Fiber Cement with EasyTrim - Trim Summary

Project Name: John Grace Arms
Location: 21030 Indian St.
Project No: 99025
Project Address: Southfield, MI 48033
Date: November 06, 2025

Fiber Cement with EasyTrim - Bill Of Quantities

- Drawing reference: **"BULLETIN #1" dated 02.19.2025**
- Estimator assumed that whole wall will be replaced with Fiber Cement Panel, hence, Face Brick and Precast Stone are to be supplied with 5/16" EasyTrim. See page 11.**

TRIM ALLOCATIONS

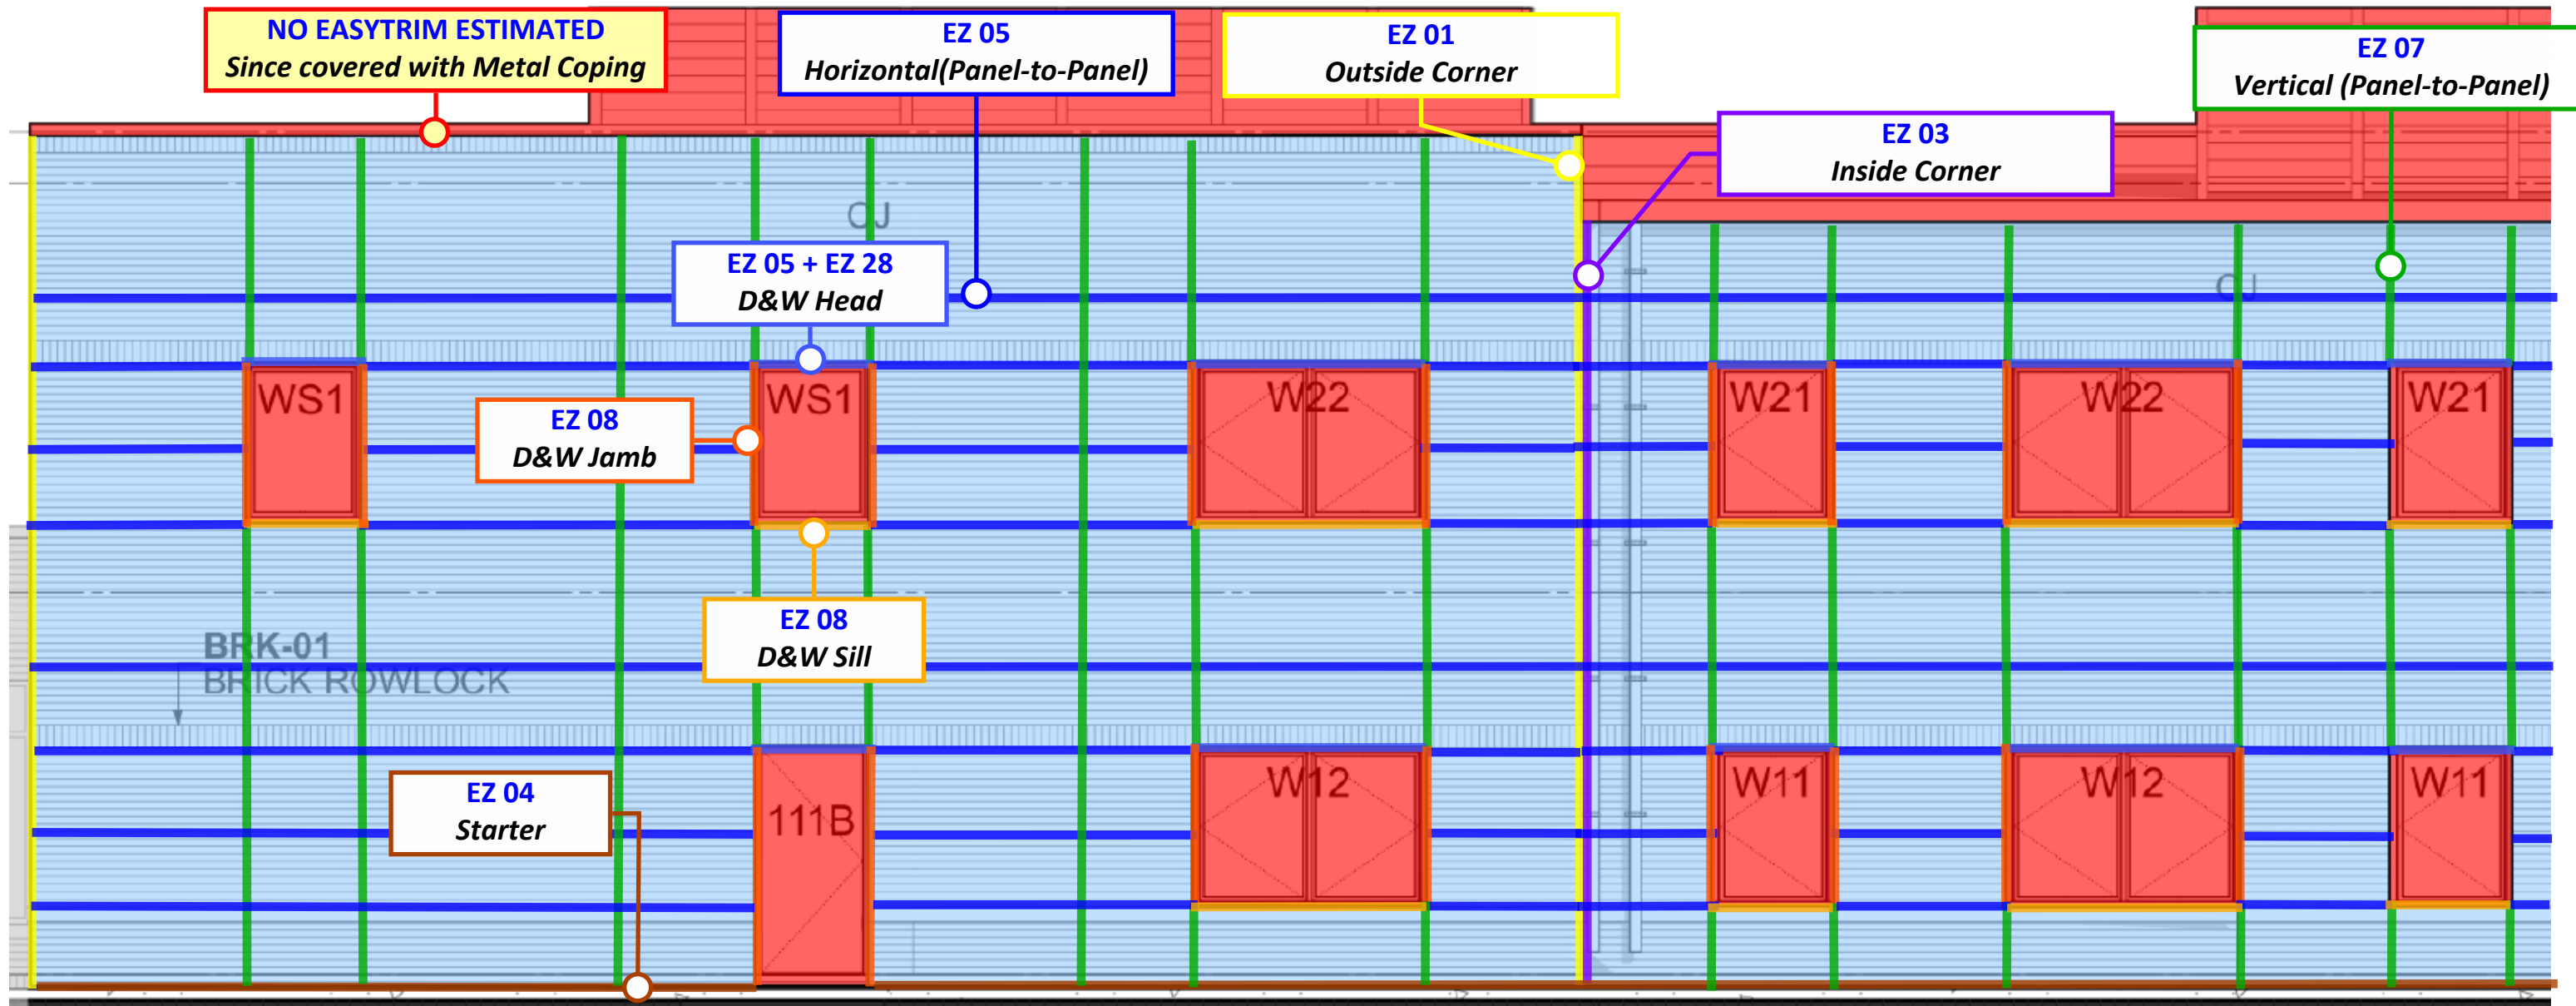
WALLS: BRK-01 - Face Brick replaced with Fiber Cement Panels -
For Supply of 5/16" EasyTrim as alt. (Color: Primed, TBD)

Material - **BY OTHERS.** Not Estimated since Not Requested.

FOR CLIENT'S APPROVAL | GRID PATTERN

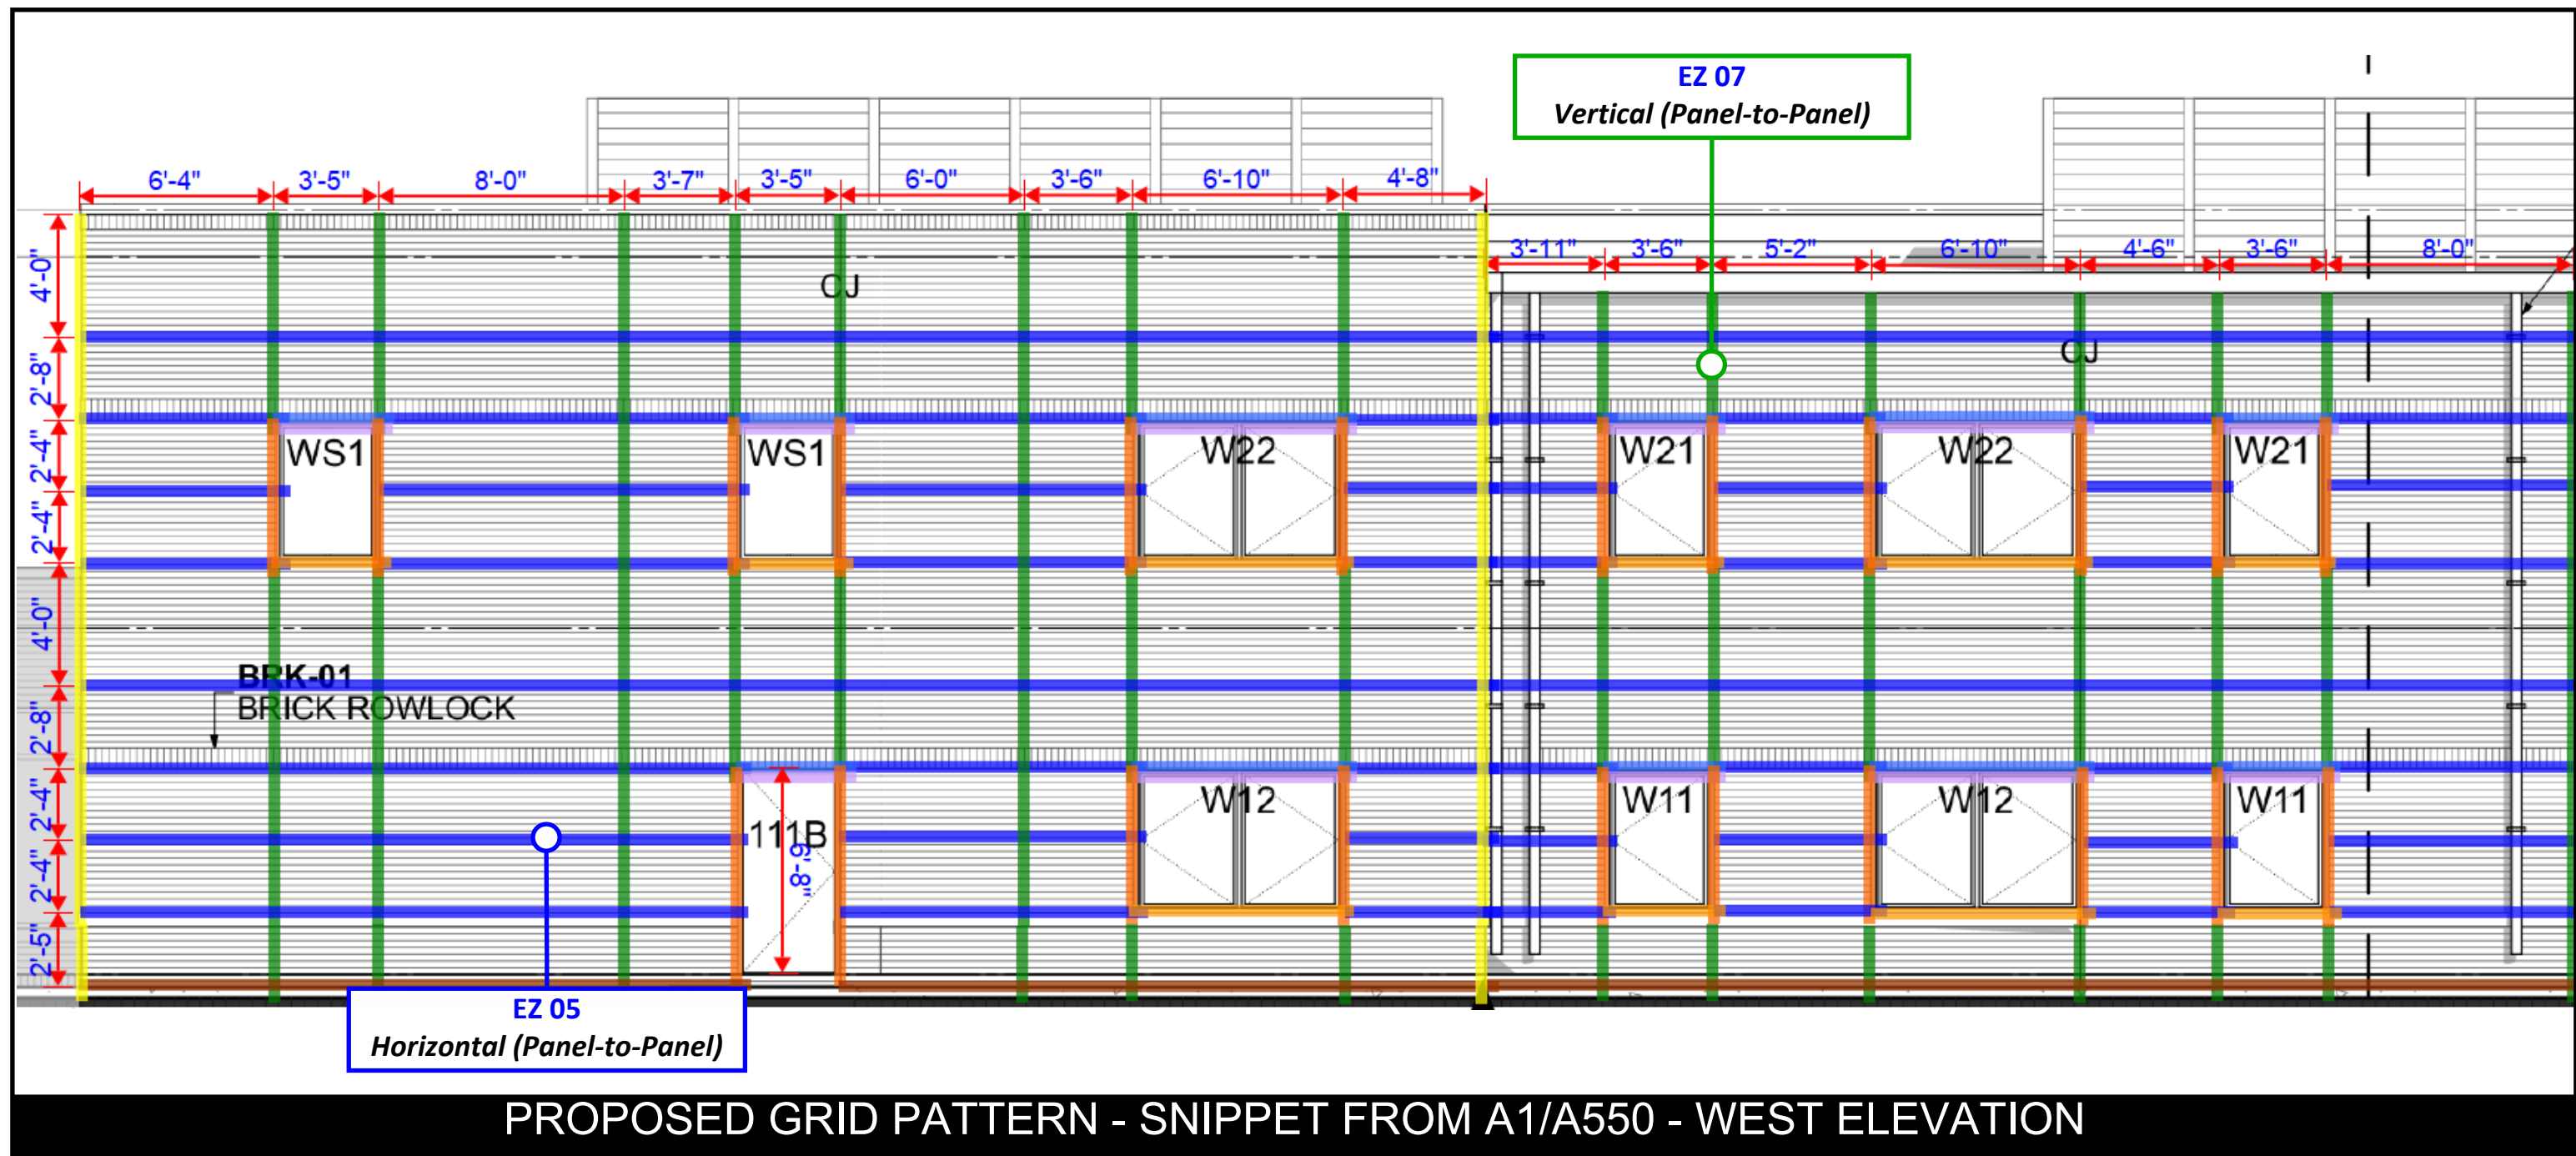
FOR CLIENT'S APPROVAL, PRIOR TO ORDERING:

The estimator's proposed grid pattern follows minimum panel dimensions of 4FT X 8FT. Trim pattern adjusted to match the alignment of adjacent windows for consistent appearance. See detailed takeoff on pages 22-25.

IMPORTANT NOTES | TOP OF WALL

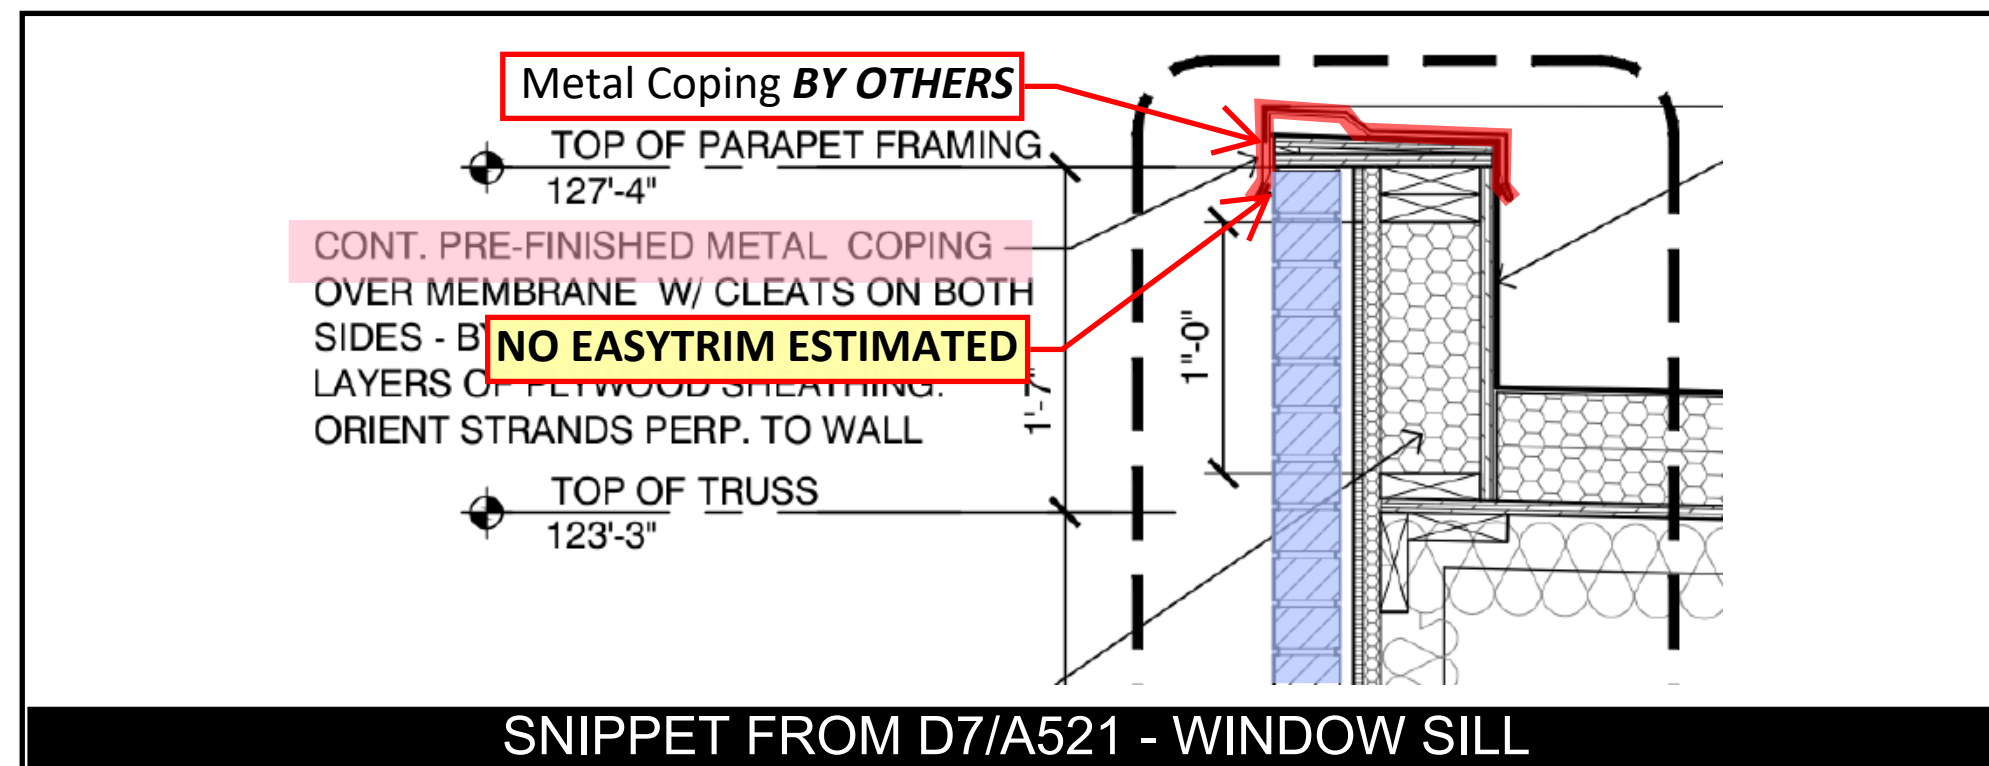
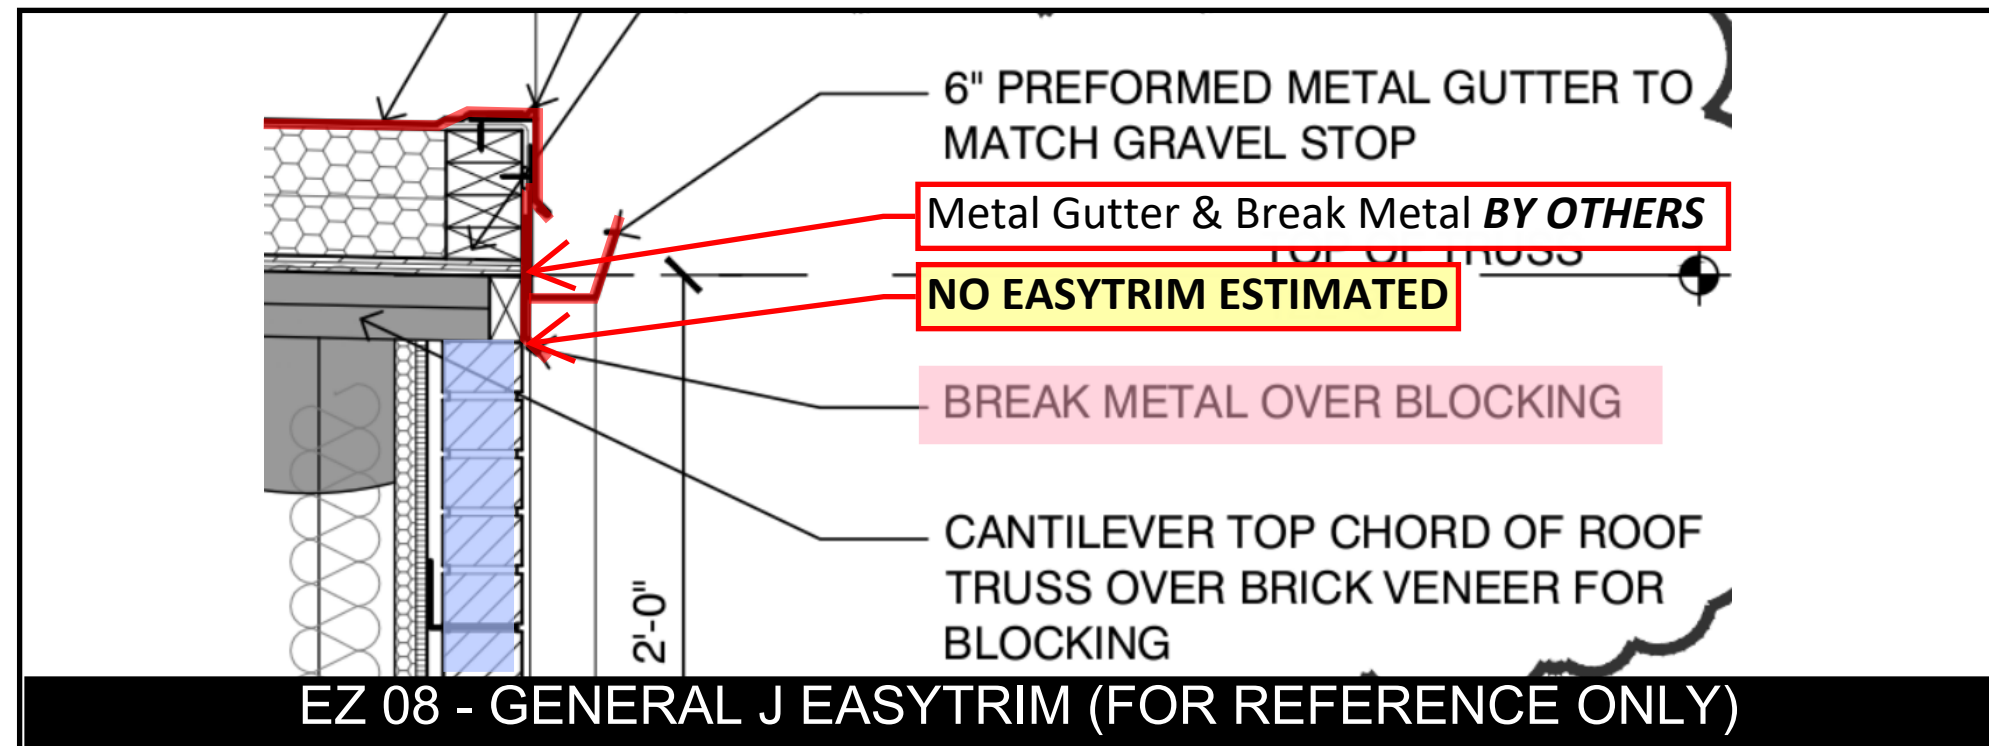
IMPORTANT NOTE:

NO Top of Wall EasyTrim estimated on areas covered with Metal Coping and Break Metal.
